Our Ref: GLN_10801_IPART Submission_June24

RE: Submission - Review of Penrith City Council's Glenmore Park Stage 3 Contributions Plan

GP3 SECTION 7.11 PLAN: TECHNICAL DRAWINGS CHAIN-O-PONDS & THE NORTHERN ROAD, MULGOA

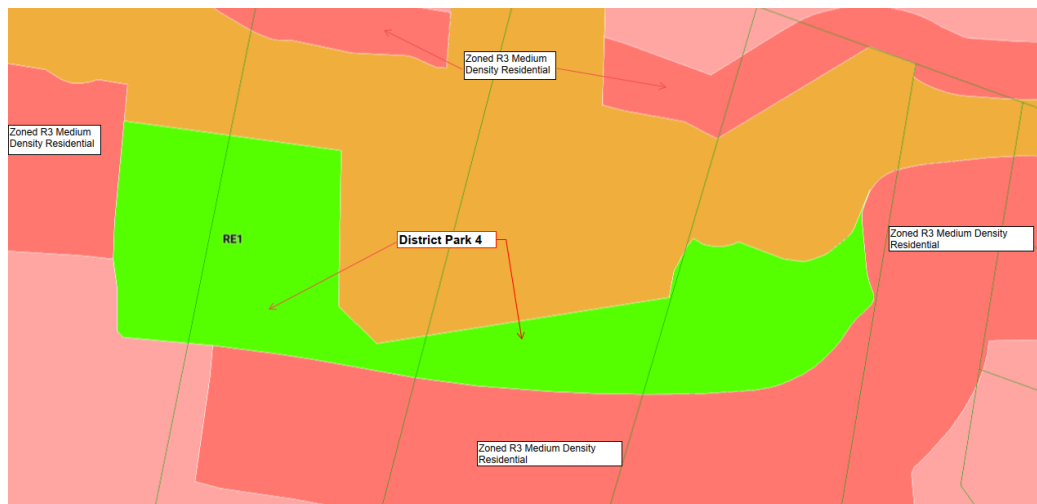
The application of the Section 7.12 approach would be acceptable so long as it does not lead to unreasonable s7.11 contributions being imposed on the rest of the developable land in the Contributions Plan. The Section 7.11 rates in the draft plan erroneously assume that development on R2 and R3 land will create all of the demand for all the local infrastructure in the Contributions Plan works schedule. This is incorrect as the retail, commercial and other future uses on the E1 zoned land will also generate demand for the transport and drainage works in the works schedule. Failure to account for this sharing of demand between development on E1 zoned land and Residential zoned land results in unreasonable residential contributions.

This creates a situation where Council are collecting a contribution above the total value of works required to service the precinct. By contrast, Council's Orchard Hills North Contributions plan applies a portion of infrastructure costs to non-residential land based on a rate per hectare of NDA, while reducing the overall \$7.11 contribution applied to residential development.

The E2 Zoned Land in GP3 represents approximately 2% of the total NDA. Approximately 2% of the total costs of transport and water cycle facilities in the draft CP are therefore attributable to the development on E1 land. Or, more to the point, residential zoned land cannot be required to meet 100% of these costs, but instead approximately 98%. On this basis, we recommend that IPART use this or another acceptable apportionment method to ensure that the residential contributions in the draft plan are reasonable.

Figure 2. Entry Boulevard Chain-O-Ponds Road Roundabout

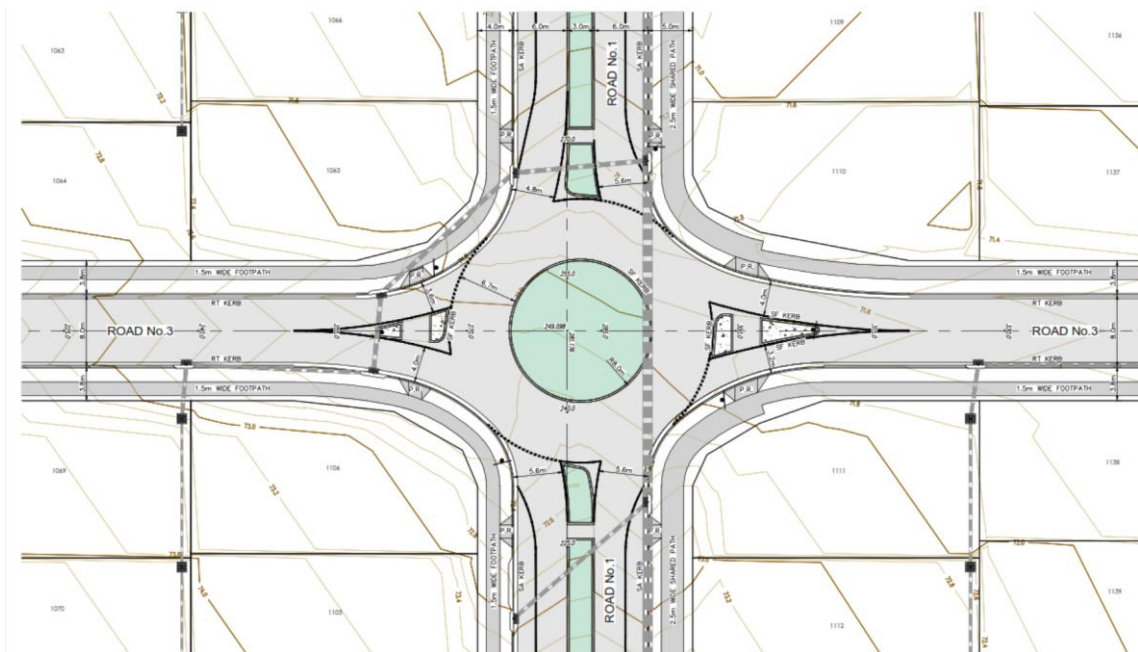
Since the rezoning of the GP3 release area, Mirvac has submitted a development application (reference DA23/0955) for residential subdivision, civil works and landscape embellishments at Stage 1 of the release area, which is currently being assessed by Penrith City Council. As part of assessment of the development application, Council has requested an additional roundabout (Intersection 6) to be included along the Entry Boulevard connecting to Chain-O-Ponds Road (refer to **Figure 2** below). Mirvac has commissioned additional costing for this item, estimated to be \$451,500 (excluding contingency and professional fees) (refer Attachment A) and a sketch as part of the revised technical drawings, which are provided for IPART's consideration at **Attachment B**. Mirvac recommends the Intersection 6 works and land are included in the Contributions Plan.
